Subject: Saxton Nuclear Experimental Corporation  
Operating License No. DPR-4  
Docket No. 50-146  
Response to the Second Request for Additional Information Regarding  
Technical Specification Change Request No. 57 dated May 5, 1996.

The purpose of this letter is to submit the response to the Second Request for Additional Information regarding Technical Specification Change Request No. 57, which addresses the proposed expansion of permissible work scope at the SNEC facility.

**FIGURE 1 (Rev. 1)**

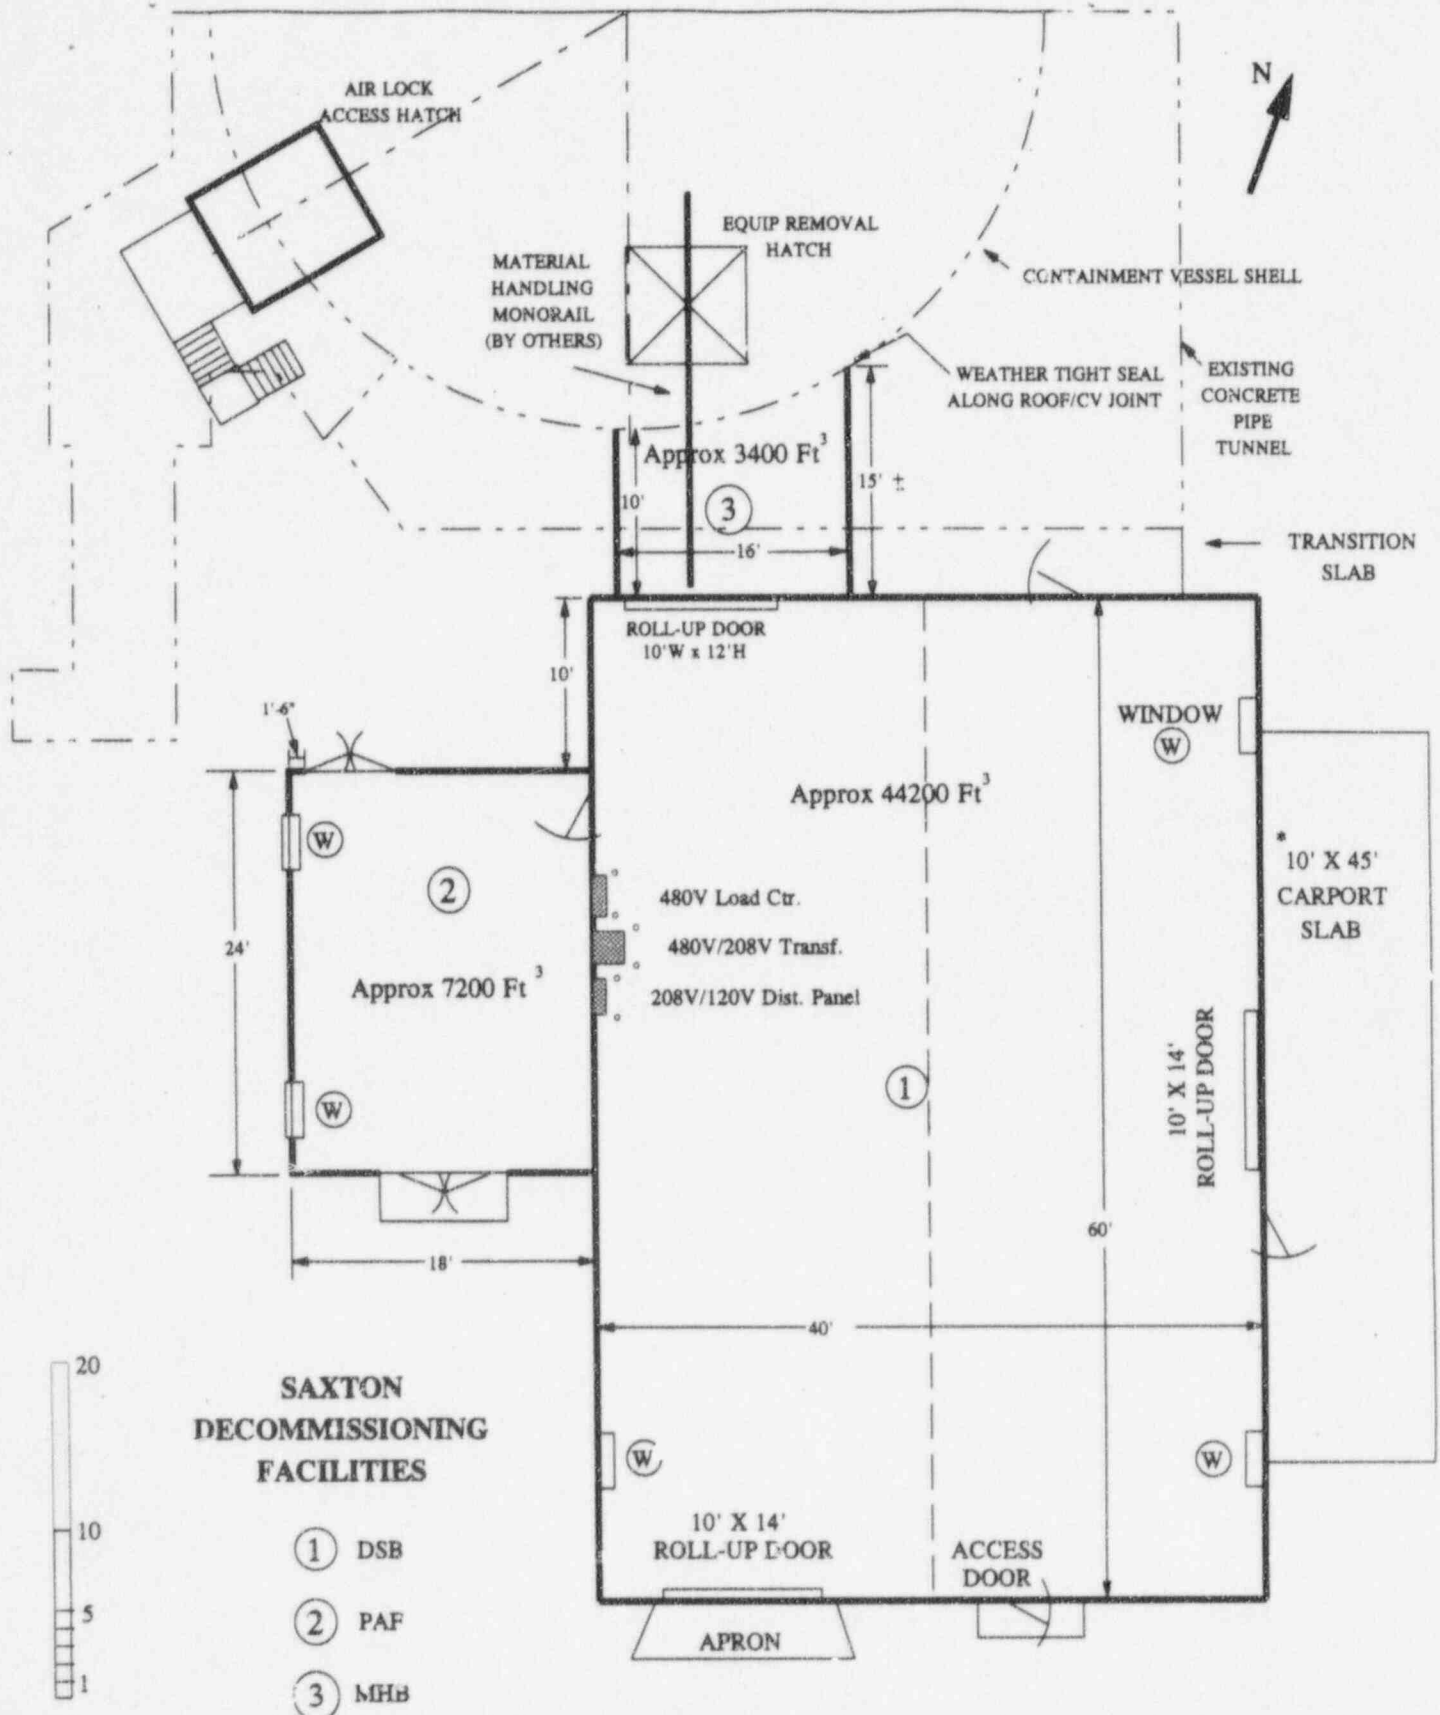
Question 2: What is the size of your proposed decommissioning support facilities?

Response: The decommissioning support facility dimensions are as described below and depicted on Figure 1 (Attachment 2):

- Decommissioning Support building is a 40 by 60 foot, 18 foot high single story structure;
- Personnel Access Facility is a 18 by 24 foot, 16.5 foot high single story structure; and
- Material Handling Bay is 16 feet wide and conforms to the exterior of the CV.
